Project: Chairman's Sanctuary (Sovereign Gaming), Level 3, The Star
Document Reference: 21231-DA-001
Revision: B

Development Application | Fire Engineering Letter of Support

Figure 5: Figure 6-2 from WSP FER noting location of fire walls on western facade

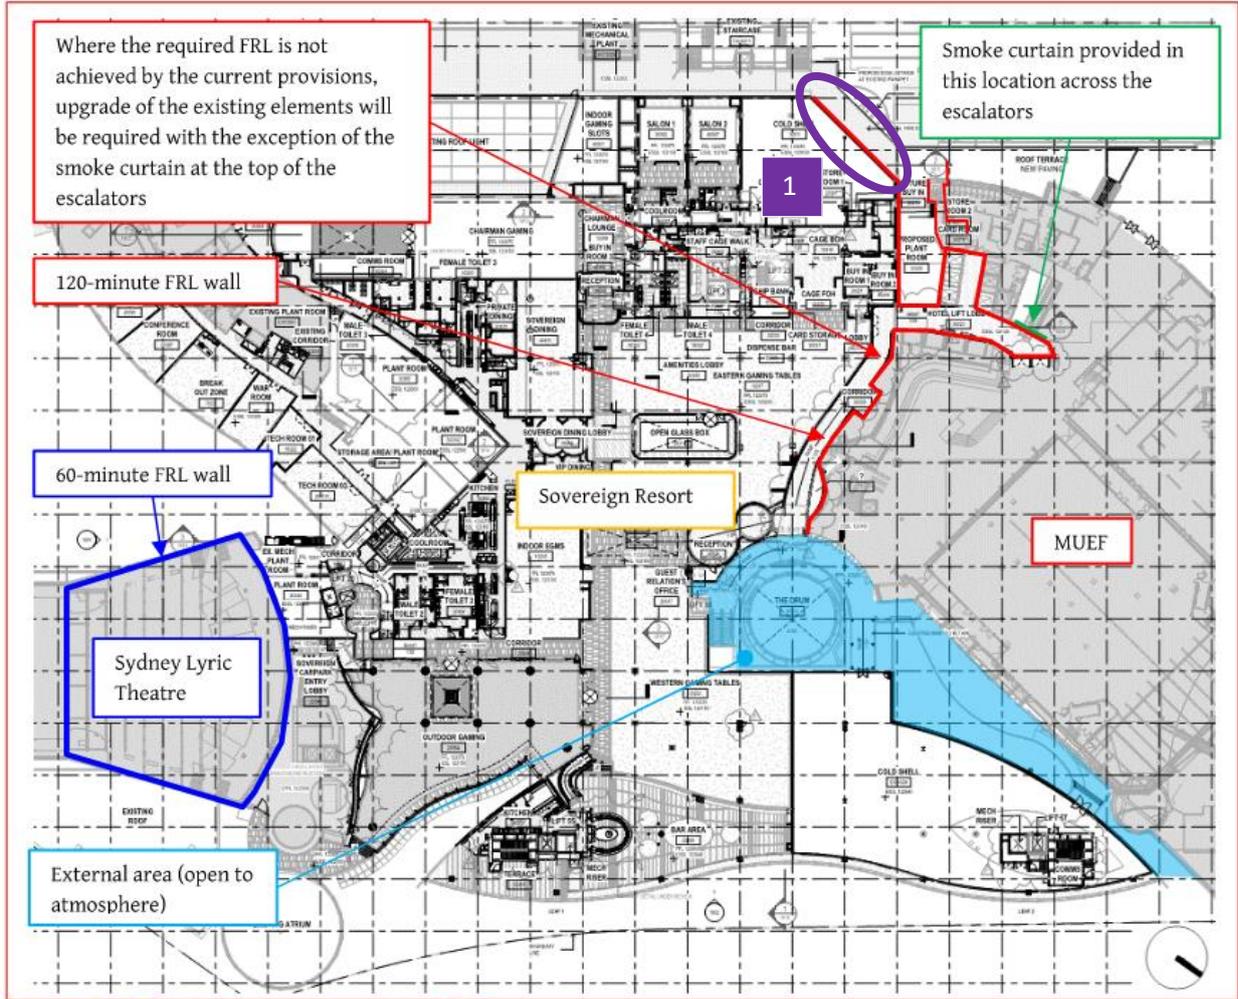
1. The external pathway leading to the 6 m exit to the west of the floor will no longer be protected by a fire wall along that façade. Instead, further evacuation modelling will be used to demonstrate that occupants can reach an alternative exit without being put at risk.

Figure 6: Figure 6-1 from WSP FER identifying egress routes and final exit points

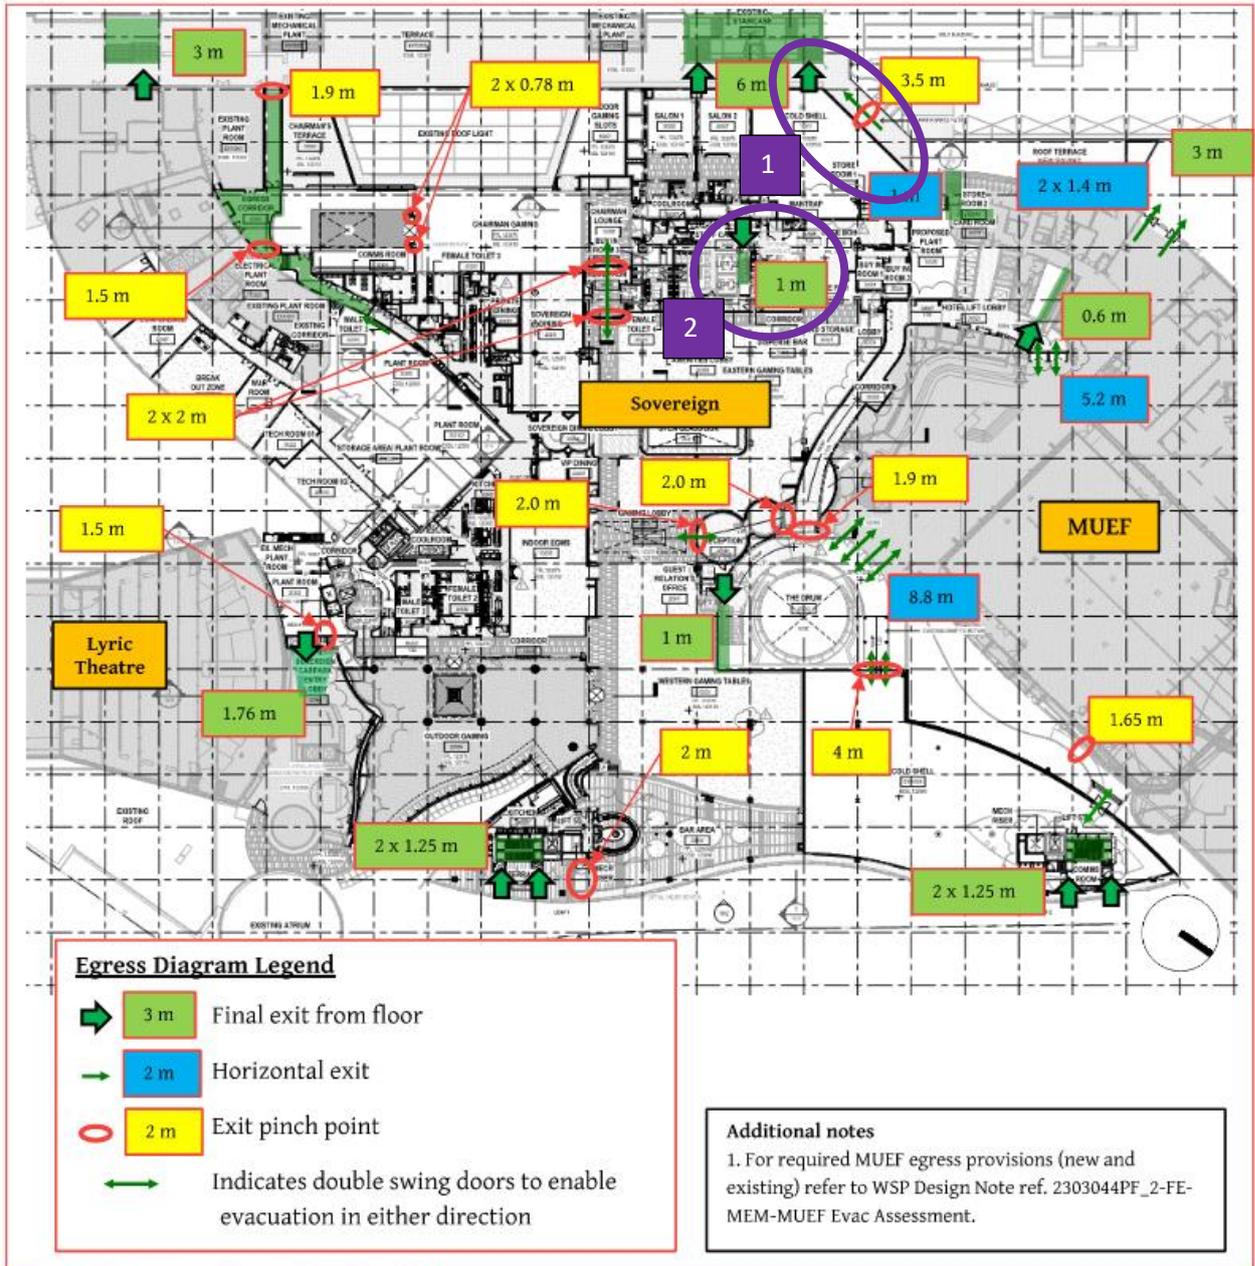
2. The existing back of house exit stair is to be reinstated as an evacuation route as part of these works. This stair is already constructed but had not been used for evacuation when the Sovereign Gaming works were signed off as it wasn't needed at that time.

3. Egress routes, based on the current design and the reinstatement of the back of house exit stair referred to in Item 2 above, are understood to be in accordance with the existing WSP FER (travel distances are not marked on Figure 5 and Figure 6 on the following pages). The existing assessment justifies the following extended travel distances from this space:

- a. Travel to a point-of-choice of 37 m, in lieu of 20 m
 - b. Travel to the nearest exit of 67 m, in lieu of 40 m
 - c. Travel distance between alternative exits of up to 94 m, in lieu of 60 m
